**STAFF REPORT  
SPECIAL CERTIFICATE OF APPROPRIATENESS  
FOR THE PROPERTY AT  
1015 SEVILLA AVENUE  
A CONTRIBUTING RESOURCE WITHIN  
THE “CORAL ROCK RESIDENCES THEMATIC GROUP”**

- Proposal: The application requests design approval for the demolition of an existing auxiliary structure, the construction of a new detached garage, an addition and alterations to the residence, and sitework. A variance has also been requested from Article 2, Section 2-101 D (4) c. of the Coral Gables Zoning Code for the minimum rear setback for the porch at the new detached garage structure.
- Architect: Patrick Valent
- Owner: Peter and Catherine Eskra
- Folio Number: 03-4118-001-1380
- Legal Description: Lots 14 & 15, Block 14, Coral Gables Section “A,” according to the Plat thereof, as recorded in Plat Book 5, at Page 102, of the Public Records of Miami-Dade County, Florida.
- Site Characteristics: The property is located on the north side of Sevilla Avenue between Cordova Street and Granada Boulevard, just west of the De Soto Fountain. The lot dimensions are 100’ x 151’.

**Figure 5: Detail of South Elevation of Existing Garage**

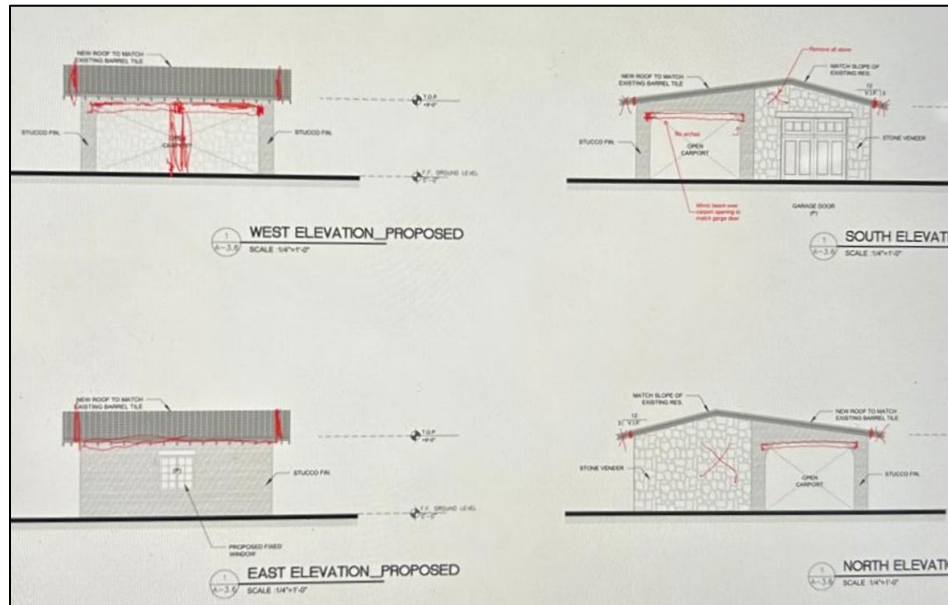
- The conversion of the existing original two-car garage into living space. The existing interior partitions will be removed, and the new living space consists of a den, kitchenette, laundry, and full bath. The floor plan on Sheet A-1.1 and elevation shown on 1/A-3.4 do not indicate a window on the south elevation that is existing and appears to be removed. As its location is not indicated correctly on the demolition floor plan, it is not clear if it can be retained. If it is not, the existing sill and lintel are to remain with the original opening recessed. It is also not clear but appears from subtle shifts in the window and door openings that the floor is to be raised. Staff recommends that the floor level be maintained to minimize impact on the exterior of the structure.

At the north end of the breezeway/south façade of the existing garage (Figure 5 and 1/A-3.4) it appears that the coral wall is being extended upwards, penetrating the existing garage roof eave. The renderings provide a different detail so it is unclear to Staff what the intent is and does not support building up the coral wall as shown. Lowering the breezeway roof might help this connection as well.

14. Maintain the existing window at the south façade of the existing garage or infill as described below.
15. Existing garage door openings (width and height) and unifying lintel are to remain

**Figures 6: Photo of East Elevation of Existing Garage [top]; Existing Elevation on Sheet A-3.4 [bottom]**

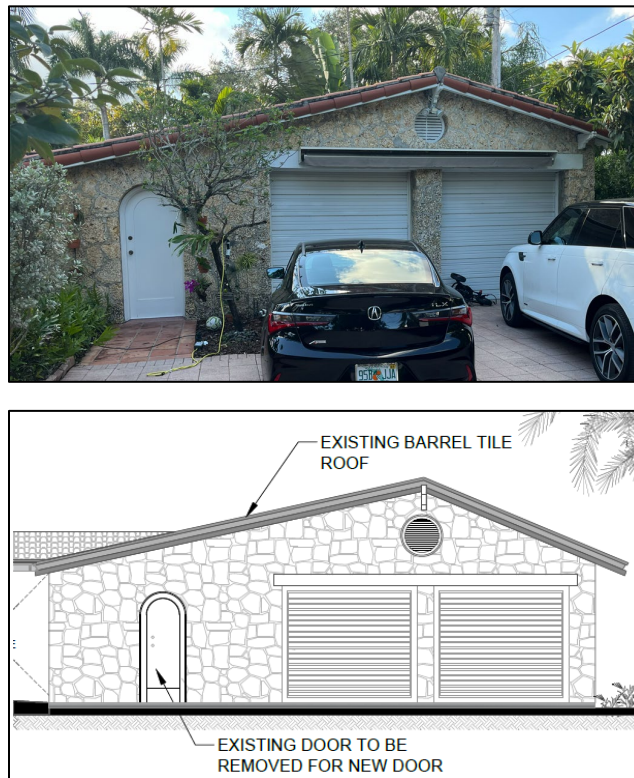
At the east elevation, the two garage door openings are proposed to be removed and infilled with a pair of French doors and sidelites. The coral rock wall separating the two garage doors is indicated to be removed and the north side of the opening infilled slightly. The coral rock wall and original openings are to be maintained.

Staff recommends that the existing finished floor elevation of the garage structure be maintained to minimize alterations to the openings. As noted above, raising the header of an arched door opening in coral rock will be almost impossible without severely impacting the existing structure. There is also not sufficient wall space to do so (see Figures 6). Likewise, the existing concrete lintels and windowsills around the home are to be maintained.

6. Window/door glass to be clear / no tint / no reflectivity / no low-e.
7. Accurate existing elevations are to be provided.
8. Work with Staff to maintain the finished floor elevation of the existing garage structure to minimize the impact on the existing window/door openings.
